Re: ERO number 019-3778
Ministry reference number 5377-C3KL6J
Permit to Take Water No. 7645-AAYS3Y servicing 1712028 Ontario Limited -
Port Colborne Quarries.

1712028 Ontario Limited - PCQ, Port Colborne Quarries Inc's (PCQ) PTTW 7645-AAYS3Y permit (PTTW) expires on August 31, 2021. PCQ has submitted a proposal for the renewal of their PTTW that was **posted on the Environmental Registry of Ontario (ERO) on June 3, 2021**. Before PCQ's PTTW is renewed I would ask you to take into consideration the following:

Figure 10: Cone of Influence with Pit 1 & 2 Rehabilitated

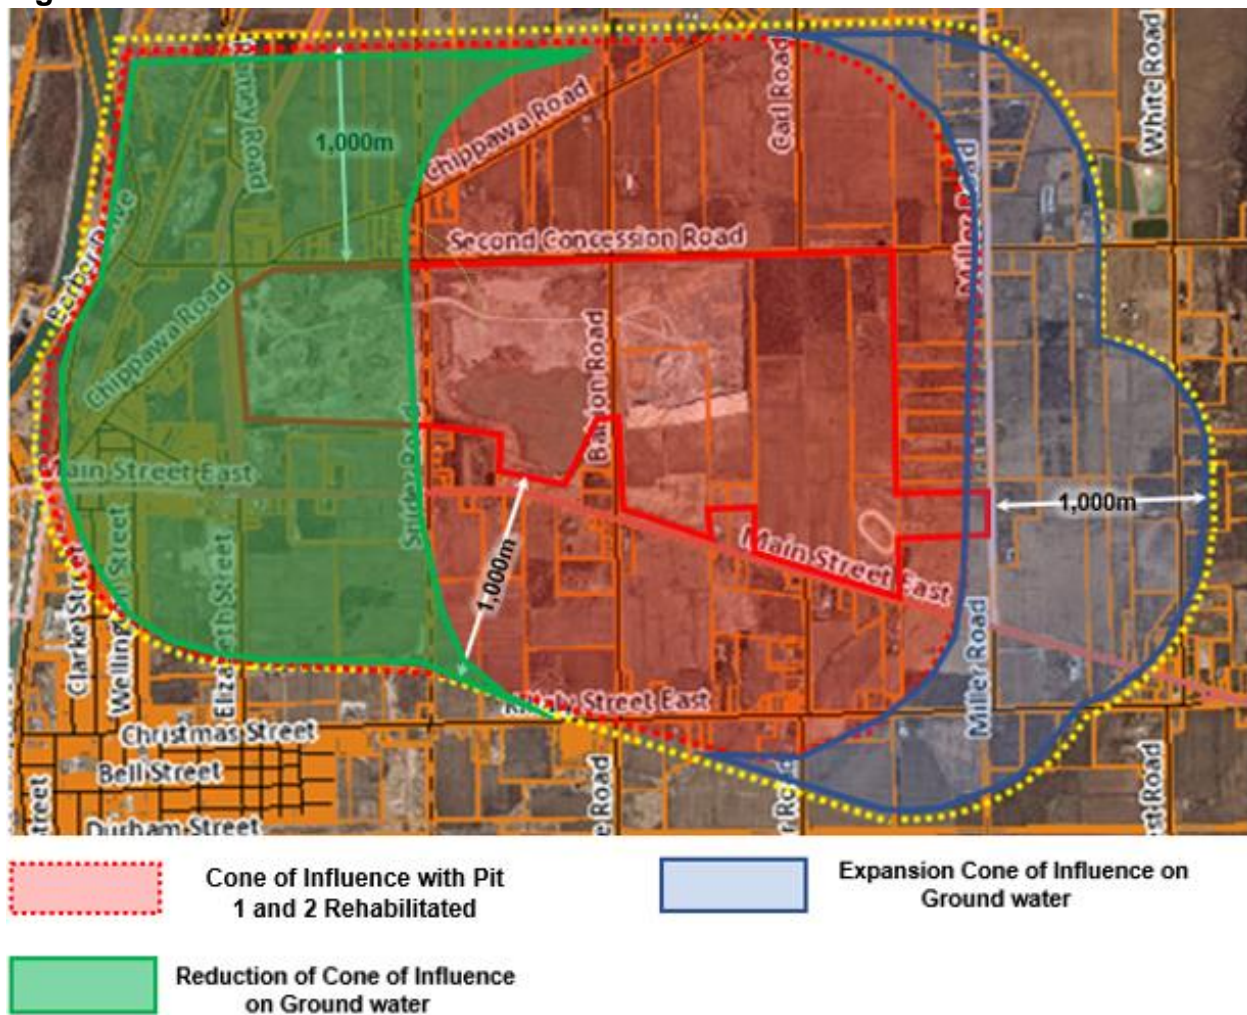
In my opinion progressive rehabilitation as defined of Pit 1 and 2 and agreed to by all parties could have reasonably been completed by now and should have. If that would have been done it would have reduced the Cone of Influence by approximately 30% as illustrated in Figure 10 below.

Progressive rehabilitation by shutting off the pumps in the depleted Pits 1 and 2 and allowing them o naturally fill with ground water could be achieved quicker and in a more environmentally enhanced way by diverting the ground water discharge from Pit 3 to the Wignell Drain to Pits 1 and 2. By doing this the Wignell Drain would not require modifications to accommodate increased flows and Pits 1 and 2 would become passive recreational lakes in a shorter period of time. As well the Highly Vulnerable Aquifer would not impacted by large volumes of draw down flows.
